**SUBDIVISION,
PLANNED UNIT DEVELOPMENT,
PLANNING APPROVAL, &
REZONING STAFF REPORT**

Date: November 17, 2011

<u>APPLICANT NAME</u>	Zion Baptist Church
<u>SUBDIVISION NAME</u>	Zion Baptist Church Subdivision
<u>DEVELOPMENT NAME</u>	Zion Baptist Church Subdivision
<u>LOCATION</u>	2514 Halls Mill Road (Northwest corner of Halls Mill Road and Pollard Lane)
<u>CITY COUNCIL DISTRICT</u>	Council District 4
<u>PRESENT ZONING</u>	R-1, Single Family Residential & B-3, Commercial Business District
<u>PROPOSED ZONING</u>	R-1, Single-Family Residential District
<u>AREA OF PROPERTY</u>	5.6± Acres
<u>CONTEMPLATED USE</u>	<p>Subdivision Approval to create two legal lots of record from an existing two legal lots of record and two metes and bounds parcels; Planned Unit Development to allow multiple buildings on a single building site, Planning Approval to allow an existing church in an R-1, Single-Family Residential District, and rezoning from R-1, Single-Family Residential District and B-3, Community Business District, to R-1, Single-Family Residential District to eliminate split zoning in a proposed subdivision and request to waive construction of a sidewalk along Halls Mill Road and Pollard La

SITE PLAN

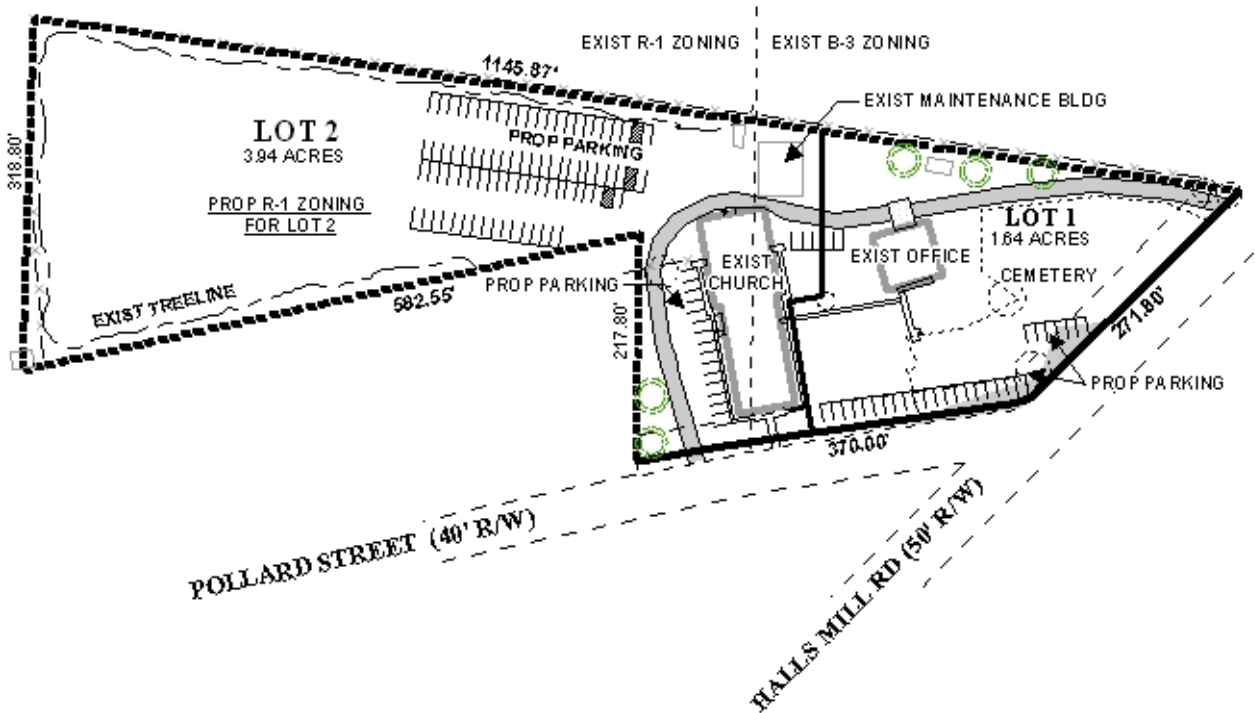
Revised: Driveway number, size, location and design to be approved by Traffic Engineering and conform to AASHTO standards. As shown, the 10' asphalt drive is not wide enough to accommodate two-way traffic. A 14'-16' aisle is the minimum desirable width to designate an entrance as one-way. Also the gate at Halls Mill Road may prohibit circulation through the site if it is common practice to keep the gate closed or locked. Two-way traffic cannot occur between the maintenance building and the church; one-way traffic is very constrained. Parking stalls along Pollard Street are not accurately depicted in the site plan. Several of the "stalls" are less than 20' from the edge of the roadway. Any parking that requires backing into the right-of-way or parking within the right-of-way is not recommended. Excess asphalt and/or gravel surfaces within the right-of-way that are not permitted to be utilized as parking through a right-of-way use agreement should be removed. There is no existing designated handicap parking and the site plan does not show adequate facilities to account for handicap accessibility (for example, proper parking stall size, aisles and solid surface access to the structures).

The applicant submitted revised detailed site plans; however, the plans illustrate several issues associated with the safety and welfare of the congregation of the church. The site plan illustrates approximately 23 parking spaces providing maneuvering within the right-of-way along Pollard Street and within the intersection of Halls Mill Road and Pollard Street; therefore, these parking spaces should be eliminated due to the proximity within the right-of-way. As the site plan submitted by the applicants, proposed Lot 2 provides ample space to provide the required parking for the church and the associated cemetery located on Lot 1. As stated in Traffic Engineering comments, "the 10' asphalt drive is not wide enough to accommodate two-way traffic. A 14'-16' aisle is the minimum desirable width to designate an entrance as one-way. Also the gate at Halls Mill Road may prohibit circulation through the site if it is common practice to keep the gate closed or locked. Two-way traffic cannot occur between the maintenance building and the church; one-way traffic is very constrained. Parking stalls along Pollard Street are not accurately depicted in the site plan. Several of the "stalls" are less than 20' from the edge of the roadway. Any parking that requires backing into the right-of-way or parking within the right-of-way is not recommended. Excess asphalt and/or gravel surfaces within the right-of-way that are not permitted to be utilized as parking through a right-of-way use agreement should be removed. There is no existing designated handicap parking and the site plan does not show adequate facilities to account for handicap accessibility (for example, proper parking stall size, aisles and solid surface access to the structures)."

Also illustrated on the site plan are several large Live Oak trees located within the existing parking and/or maneuvering areas, which as noted from Urban Forestry comments, should be given preservation status and protected from removal or the continued compaction of the root system by the parking of vehicles. Therefore, the removal of parking spaces and maneuvering should be required within the critical root zone of all trees designated preservation status.

The applicant submitted revised detailed site plans; however, the plans still illustrate several issues associated with the safety and welfare of the congregation of the church. As the revised site plan submitted illustrates, proposed Lot 2 does provides ample parking spaces to meet the required parking for the church and the associated cemetery located on Lot 1. As stated in Traffic Engineering comments, “the 10' asphalt drive from Lot 1 to Lot 2 is not wide enough to accommodate two-way traffic. A 14'-16' aisle is the minimum desirable width to designate an entrance as one-way. There are designated handicap parking illustrated on the site plan; however, the site plan does not show adequate facilities to account for handicap accessibility (for example, proper parking stall size, aisles and solid surface access to the structures).”

Also illustrated on the site plan are several large Live Oak trees located within the existing parking and/or maneuvering areas, which as noted from Urban Forestry comments, should be given preservation status and protected from removal or the continued compaction of the root system by the parking of vehicles. Therefore, the removal of parking spaces and maneuvering should be required within the critical root zone of all trees designated preservation status.

- 1) revision of the site plan to show **ALL** required parking spaces on Lot 2, including, but not limited to, dimensions of parking stalls or drive aisles, indicate paving materials, and indicate the seating capacity of both churches and other information needed to ensure parking compliance;*
- 2) approval of a sidewalk waiver or illustration of a sidewalk on the site plan;*
- 3) compliance with Urban Forestry Comments: "Preservation status is to be given to the 60" Live Oak Tree located on the center of Lot 1. Preservation status is to be given to the 48" Live Oak Tree, 50" Live Oak Tree and 52" Live Oak Tree on Lot 2. Any work on or*

- 1) *revision of the site plan to show **ALL** required parking spaces on Lot 2, including, but not limited to, dimensions of parking stalls or drive aisles, indicate paving materials, and indicate the seating capacity of the both churches and other information needed to ensure parking compliance;*

SIDEWALK CROSS SECTION DETAIL

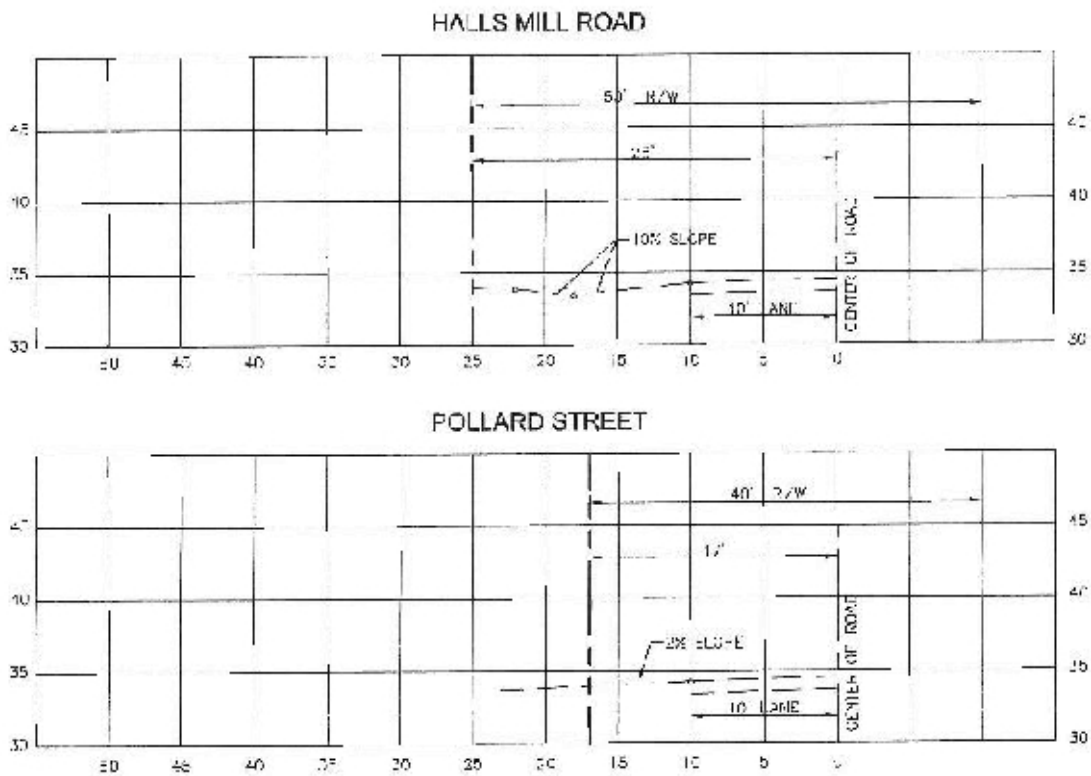
In reference to the applicant stating that there is inadequate right-of-way for the placement of a sidewalk, it should be noted that the revised preliminary plat illustrates dedication along Pollard Street; therefore, adequate right-of-way will be available for the placement of a sidewalk. Also, the applicant states that existing utilities prevent the placement of a sidewalk; however, no utilities are illustrated on the site plan submitted. The applicant goes on to state the existing ditch location makes the placement of a sidewalk not feasible. Based on the cross-sections submitted by the applicant, it appears that the locations of the potential sidewalk would be on the outside edge of the ditches, and would therefore not be impacted by them. The cemetery location appears to run along the property line; however, it should be noted that the proposed site plan illustrates parking spaces along the property line; therefore it is possible to have a sidewalk not interfere with the cemetery.

The applicant has not provided sufficient reasoning to justify the approval of the sidewalk waiver. There is no reason why a sidewalk cannot be built to City of Mobile standards; it is simply the applicant's wish to not construct a sidewalk.

Sidewalk Waiver: *Based upon the preceding, this application for waiver of the sidewalks along Hall Mill Road and Pollard Street are recommended for denial.*
